PARTS & SERVICE NEWS

REF NO. AA01055

SUBJECT: TIE ROD TORQUE SPECIFICATIONS AND MAINTENANCE

APPLICATION: Komatsu Electric Drive Dump Trucks:
930E: AFE48 & Up, A30019, A30026 & Up;
830E: AFE50-A & Up, A30544 & Up;
730E: AFE47 & Up, A30079 & Up

FIGURE 1. TYPICAL TIE ROD ASSEMBLY

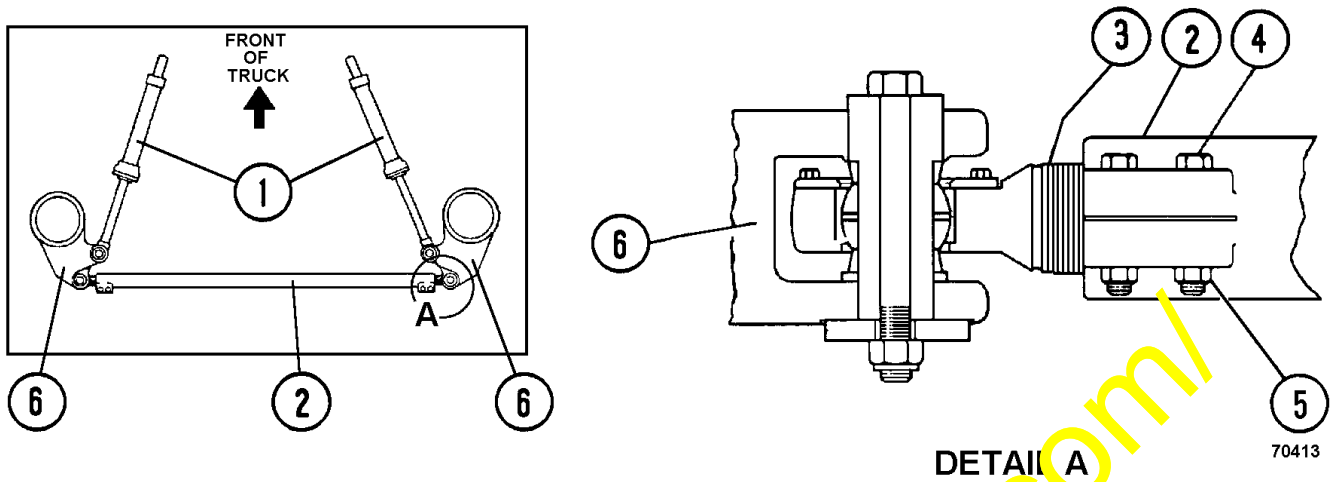
The tie rod has been installed with capscrews (4, Figure 1) at the rod end in order to allow toe adjustments. Komatsu requires that tie rod capscrews (4) be inspected and tightened at each 250 hour maintenance interval. All tie rod assemblies are assembled with 3/4" - 10NC X 4" G8 capscrews (VN9140).

Note: 830E shop manuals which specify capscrews (4) and locknuts (5) to be tightened to 208 ft.lbs. (282 Nm) torque are being revised to 310 ft.lbs.(420 Nm) torque.

1. When inspecting this area or making adjustments, shut down the engine and the turn the keyswitch to the "OFF" position.
2. After the engine has been shut down, allow at least 90 seconds for the accumulators to bleed down.
3. Turn the steering wheel to the left and to the right several times to relieve the steering accumulator pressure.
4. Block front and back of rear wheels.
5. Tighten capscrews (4) and locknuts (5) to 310 ft.lbs.(420 Nm) torque.
